Addendum No 3

Date : January 12, 2022
From : Michael Kurek – Assistant Project Manager
Subject : Addendum No. 1 to the Bidding Documents for:
Project No.: ACG File No. 21-033

Roof Rehabilitation Program Building 'D' McHenry County College

1 ROOF PLAN
 SCALE: 1/8" = 1'-0"

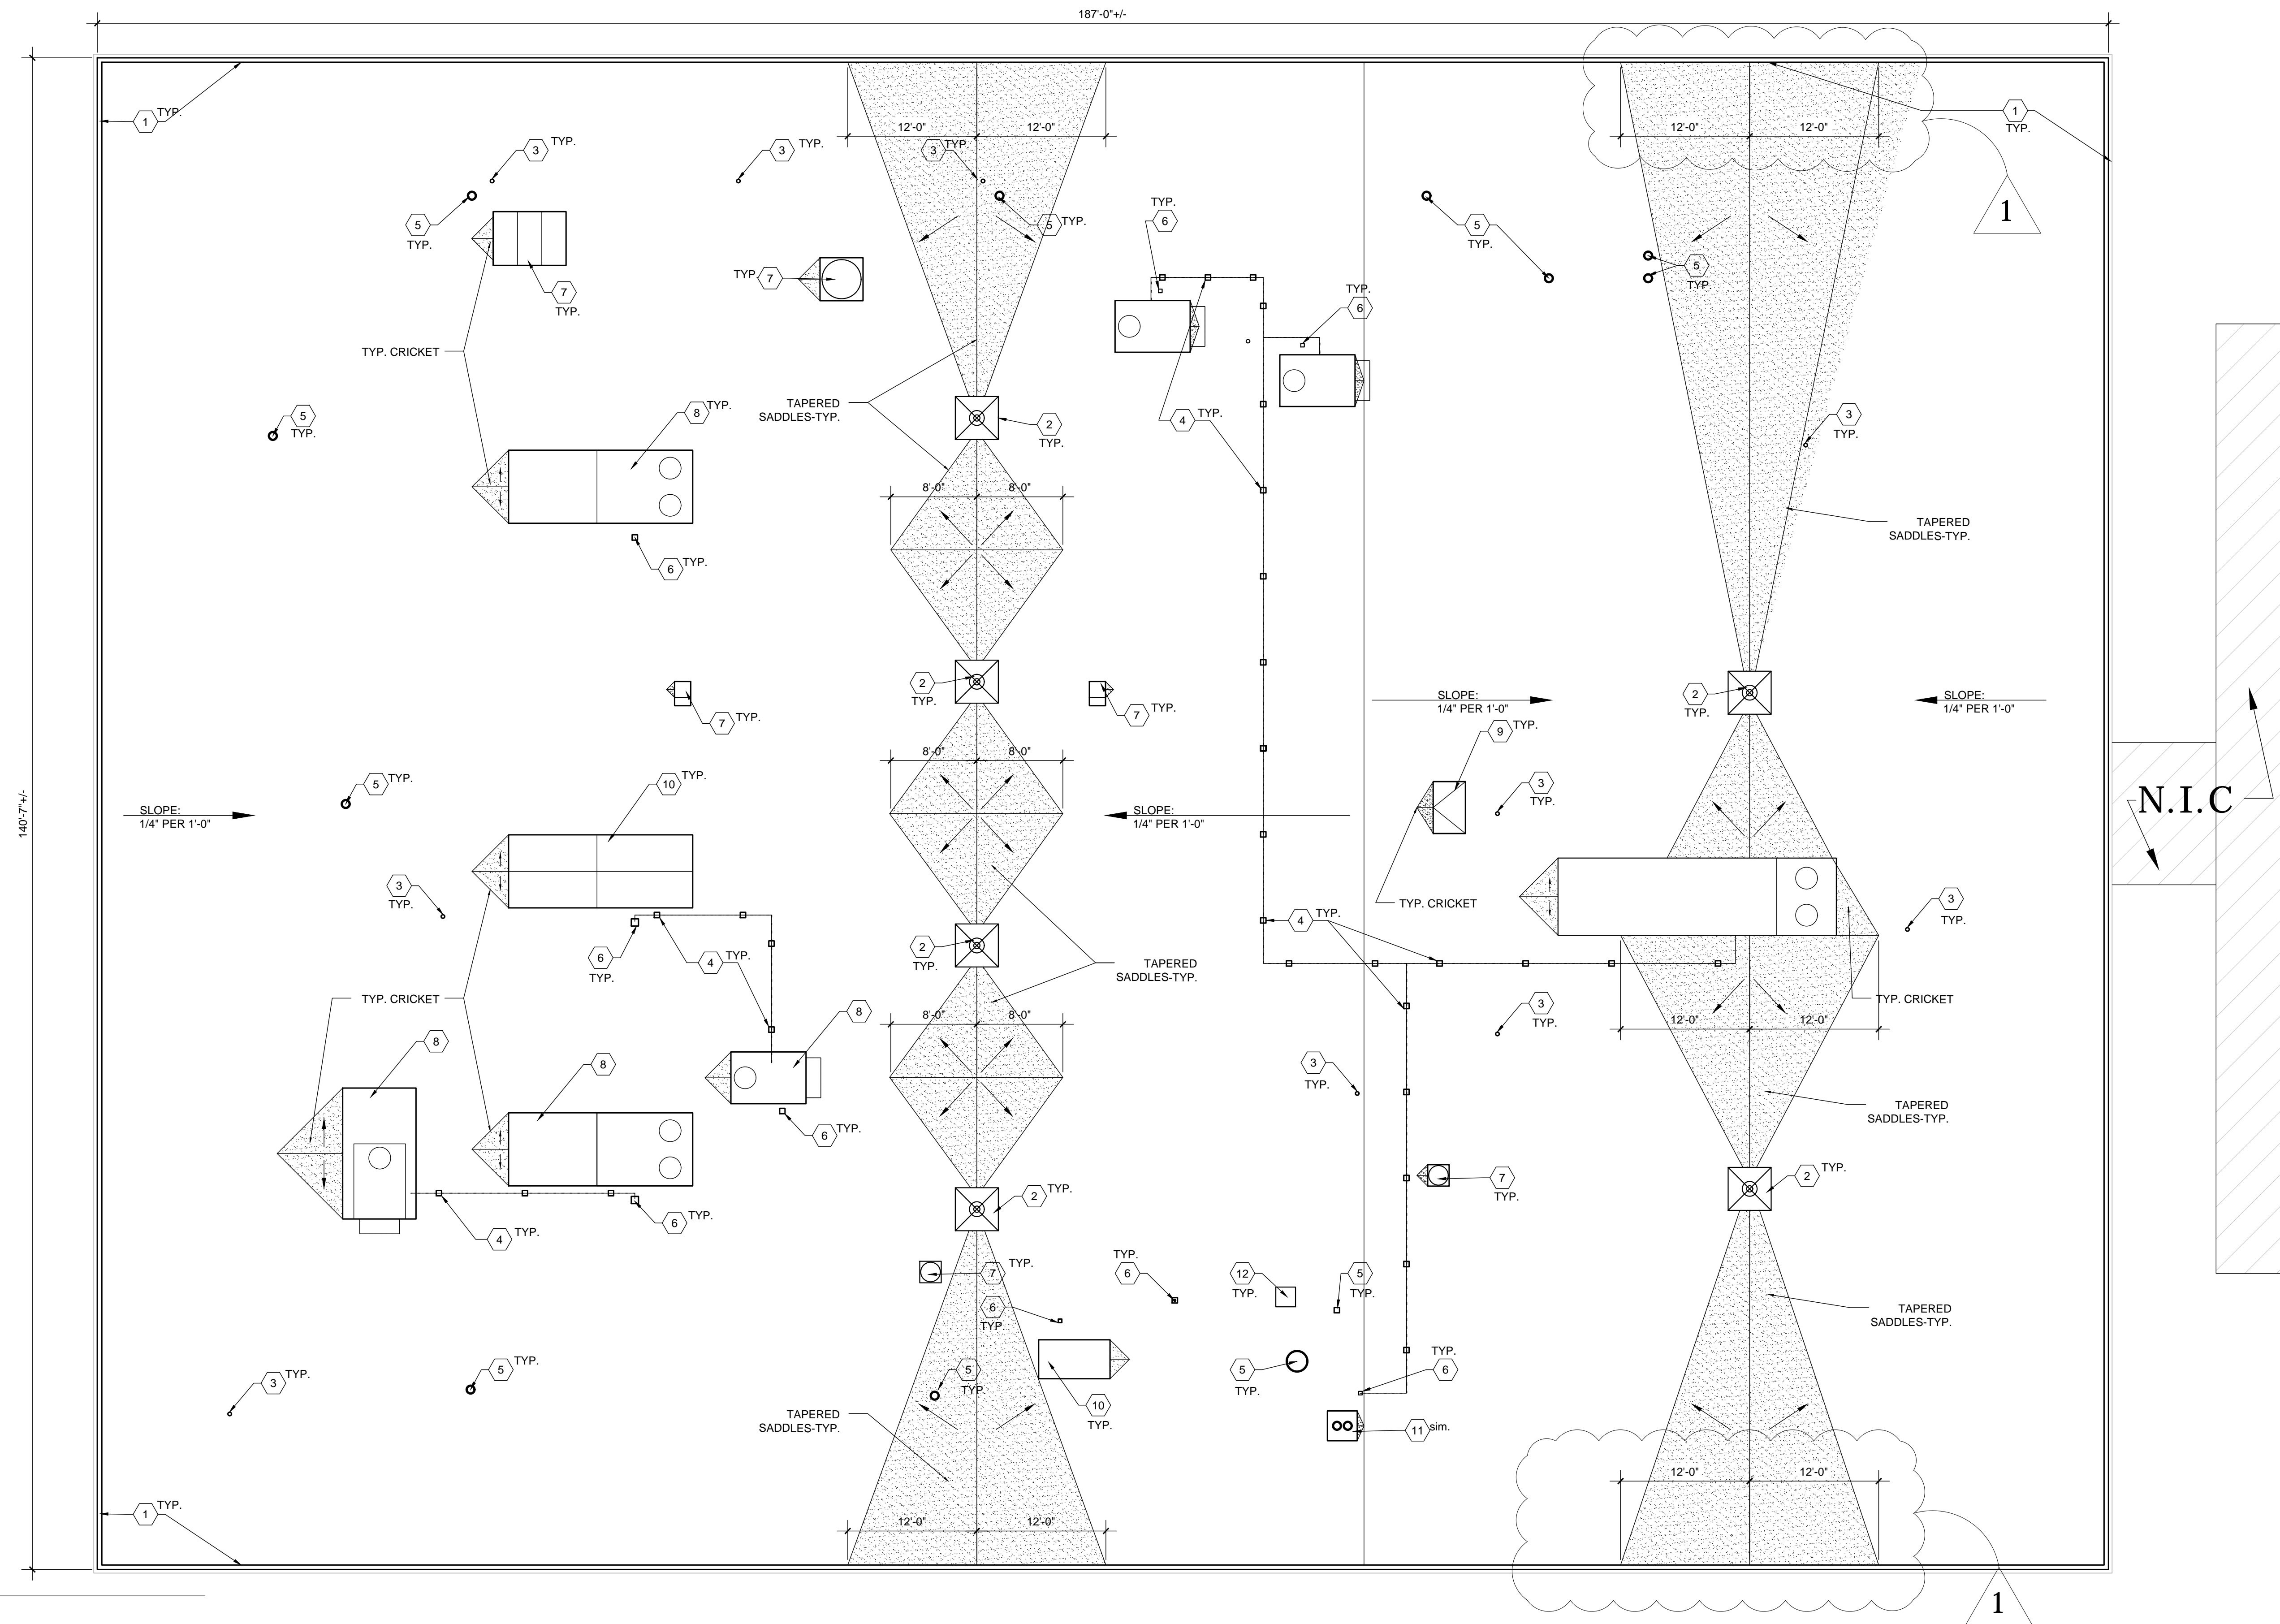
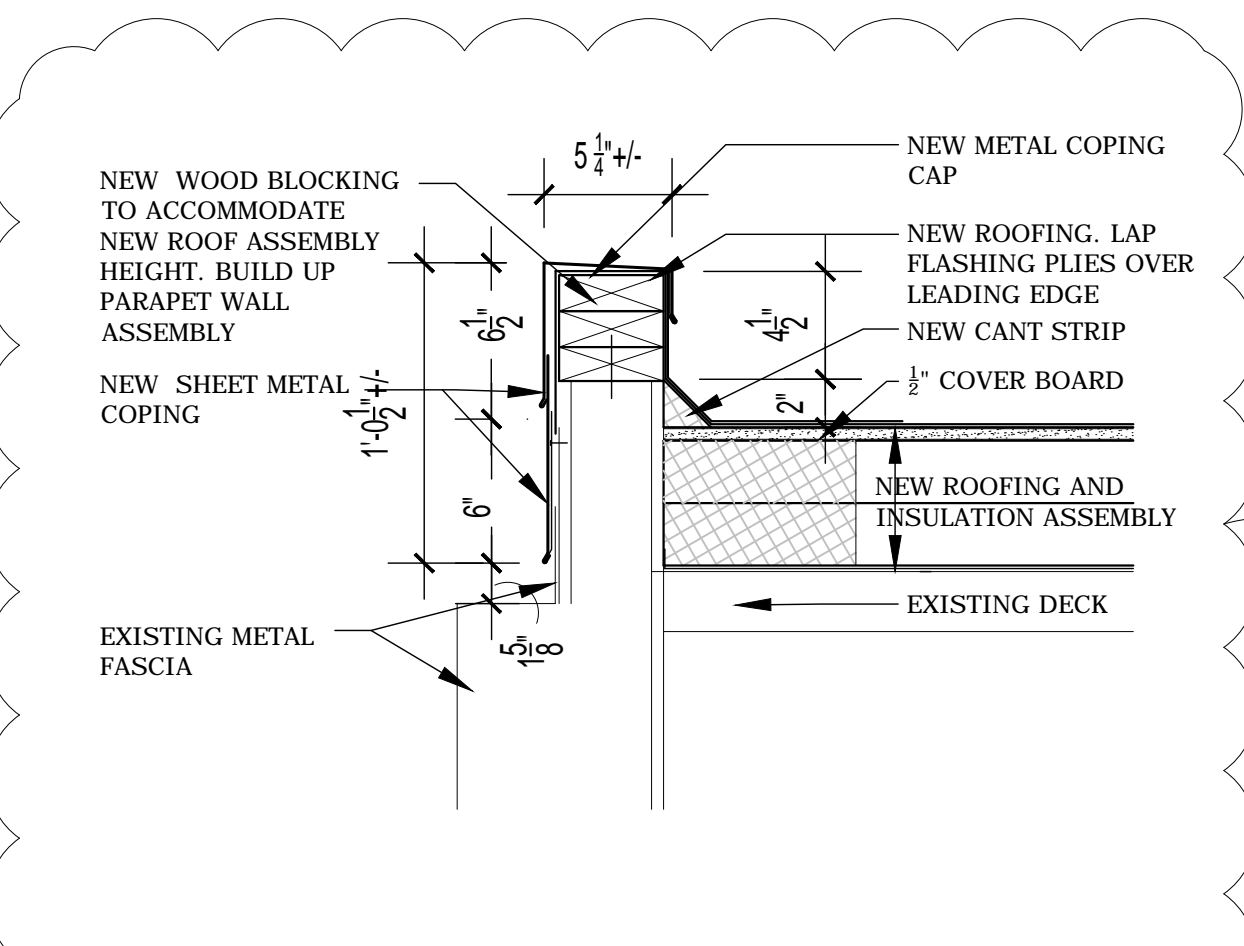
All tapered saddles are not to exceed 12' in width. See Updated Roof Plan on Sheet A1

- 2** **DRAIN DETAIL:** Remove existing roofing assembly and clamping rings. Adjust height of drain head as required. Install new insulation and roofing assembly. Provide 4x4' sumps at all drain locations with tapered insulation. Provide tapered saddles between all drains. Install lead flashing and membrane flashing. Install new clamping ring, drain dome, and stainless steel mounting hardware. Reinstall existing drain strainer using new S.S. hardware, tap and thread mountings as required. See Detail 2 / Sheet A2.
